WATER LICENCE INSPECTION FORM

File Number: 2017-KIV16-CW

Attached: Photo Log 2BB-MEA1318, - July 12th, 2017

Description: Spill 15-329

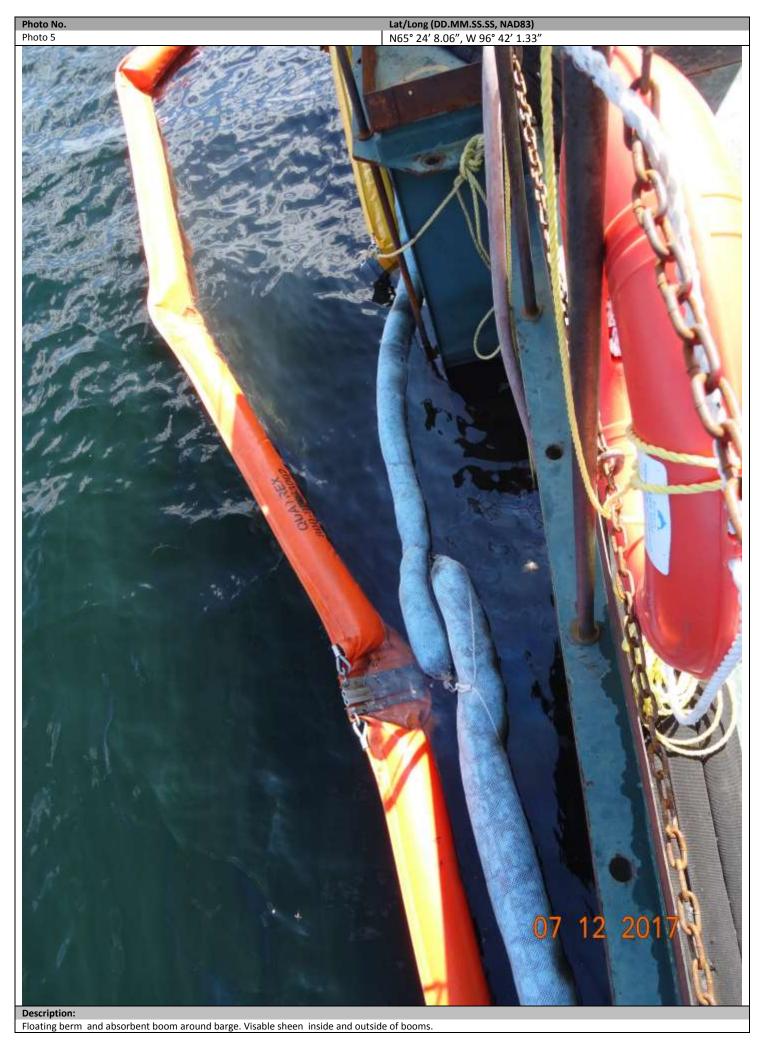
1. The reclamation of spill no. 15-329 is still ongoing (photo 2). The environment division collected samples of the spill excavation to confirm the location had been cleaned. The inspector noted an area close to the south end of jet A1 tank no.			
9 which had a strong smell of fuel.	The state of the s		
 Contaminated soil is being stored in a temporary lined structure to avoid further contamination to the environment. AEM 			
has extended the temporary structure a number of times to make additional room as spills occur.
